MIL-M-28787/298A
AMENDMENT 2
30 September 1992
SUPERSEDING
AMENDMENT 1
14 February 1986

MODULES, STANDARD ELECTRONIC

INVERTER, DIGITAL, KEY CODE RHG

FIGURE 22. Power supply transient amplitude test circuit waveforms for table XVIII.

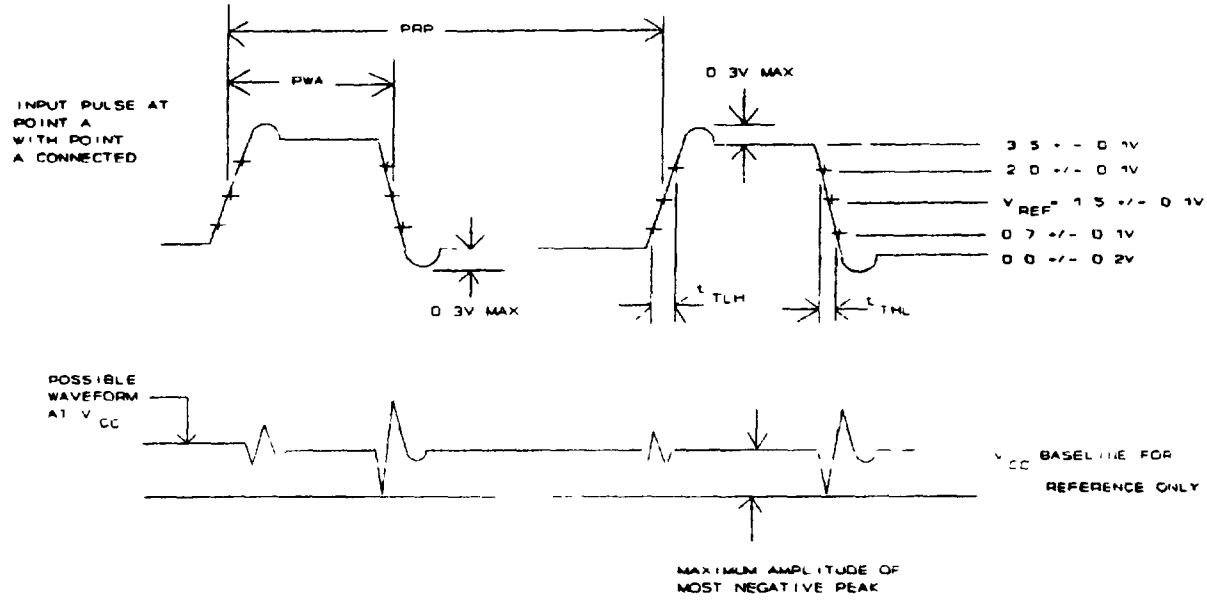
*FIGURE 22: Delete and substitute new figure 22 as printed on page 3 of this amendment.

NOTE: Input pulse parameters: With the module connected to item J05, adjust item J05 for the required pulse amplitude, pulse low level voltage and transition times. Verify the input pulse parameters at each input pin before making the measurement.

$t_{TLH} = t_{THL} = 3.5 \pm 1.5$ ns verified at each input pin.
PWA = 500 $\pm$ 50 ns.
PRP = 1,000 $\pm$ 200 ns.
